**Generic Design Assessment – New Civil Reactor Build**

**Step 4 Structural Integrity Assessment of the Westinghouse AP1000<sup>®</sup> Reactor**

Assessment Report: ONR-GDA-AR-11-011

14 November 2011

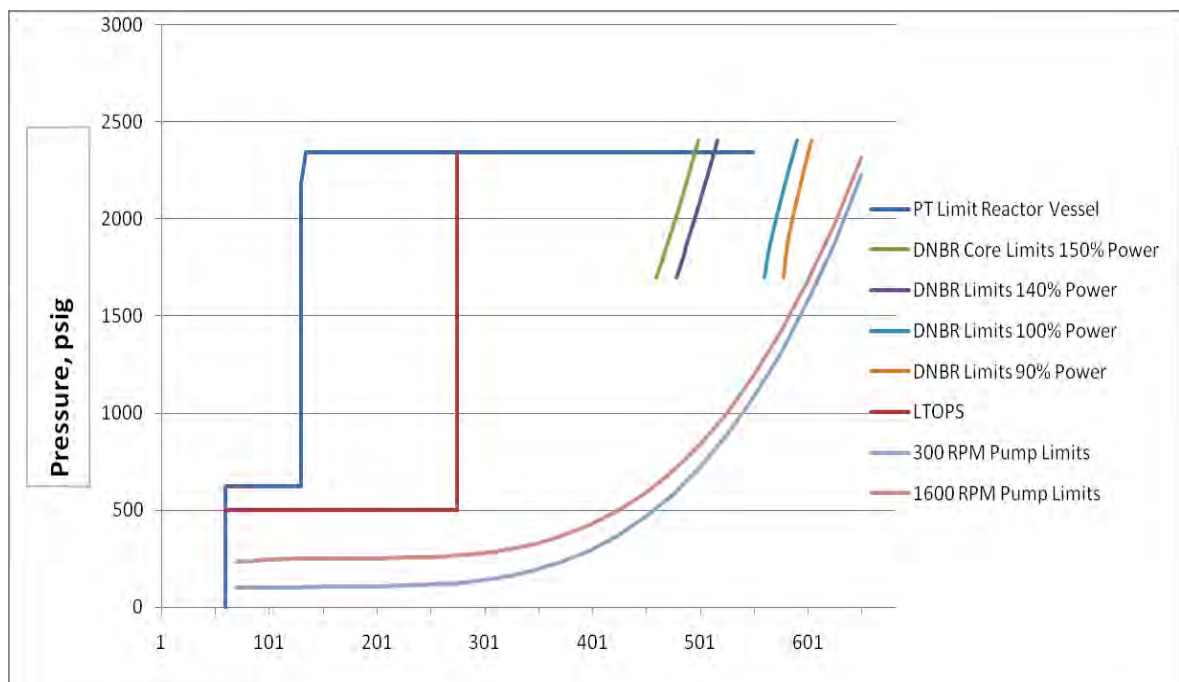
438 Oak Ridge Nuclear Laboratory (Ref. 176) presented six reasons to support the change. In summary these are:

- Because the temperature change is at a slow constant rate it is technically correct to use the static lower bound fracture toughness  $K_{1C}$ .
- $K_{1A}$  was used in 1974 when the rules were first defined to cover uncertainties, since that time a significant amount of work has been undertaken to understand these.
- The calculation assumes the presence of a large surface-breaking flaw, no such flaws have been found.
- By 1999 there was about ten times as much  $K_{1C}$  data as there had been in 1974.
- Part of the argument for using  $K_{1A}$  was to account for local brittle zones which could result in cracks popping through that zone. Subsequent work has found these are not significant.
- There are benefits in opening up the operational window which could, on balance, improve plant safety.

- 440 SERCO (Ref. 158) noted that using the  $K_{1C}$  based curve may not be demonstrably conservative if the copper content of the steel is greater than about 0.07%. Since the maximum copper content of the AP1000 RPV beltline forgings and welds is specified to be less than 0.06% this will not be an issue for a UK AP1000.
